To: T10 Technical Committee
From: Barry Olawsky, HP (barry.olawsky@hp.com)
Date: 4 October 2007
Subject: T10/07-304r3 SAS-2 Zero-Length Test Load Section

1.1.1.1 Zero-length test load

Figure 105 — Zero-length test load for transmitter device compliance point

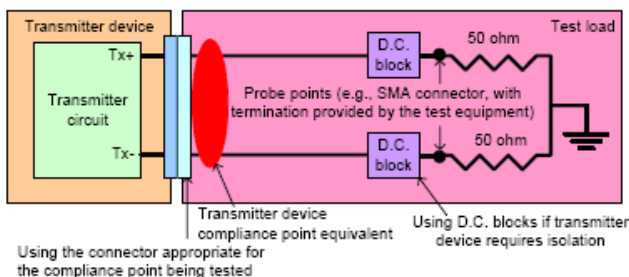
Test loads in a figure 105 and figure 106 show ideal designs. Actual designs include:

- insertion loss between the compliance and probe points; and
- return loss due one or more impedance mismatches between the compliance point and 50 ohm termination points.

Figure X, Zero-Length Sdd21

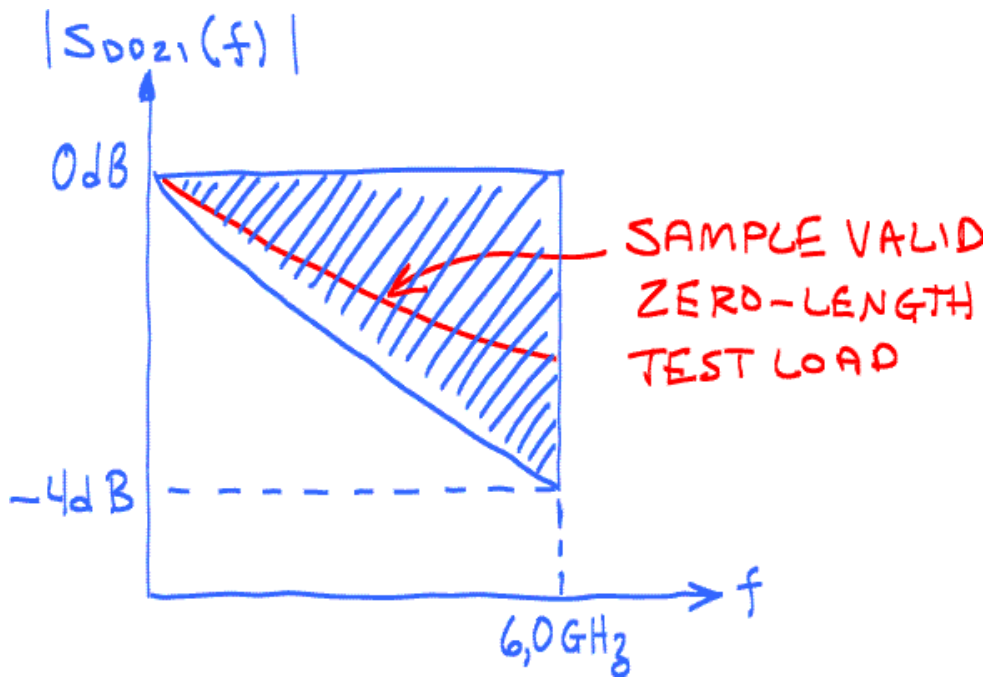
The zero-length test load, including all fixturing and instrumentation required for the measurement, shall comply with the following equations:

For 50 MHz $\leq f \leq$ 6,0 GHz:

$|S_{DD21}(f)| \geq -20 \log_{10}(e) \times ((1,0 \times 10^{-6} \times f^{0,5}) + (2,8 \times 10^{-11} \times f) + (5,3 \times 10^{-21} \times f^2)) - 0,2 \text{ dB}$ (see figure X)

$|S_{DD11}(f)| \leq -15 \text{ dB}$

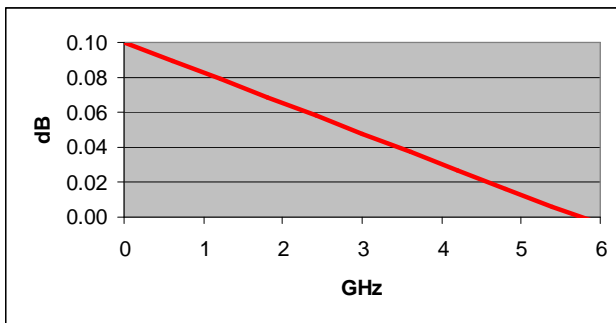
Adding a DC loss of 0.1dB and rescaling the "f" term to "3" to force 4.0dB loss at 6GHz the additional margin is:

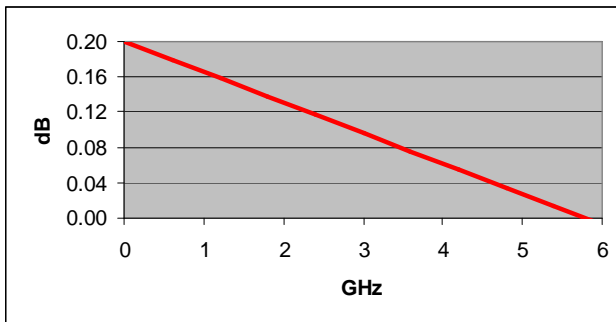
Adding a DC loss of 0.1dB and rescaling the "f" term to "2.8" to force 4.0dB loss at 6GHz the additional margin is:
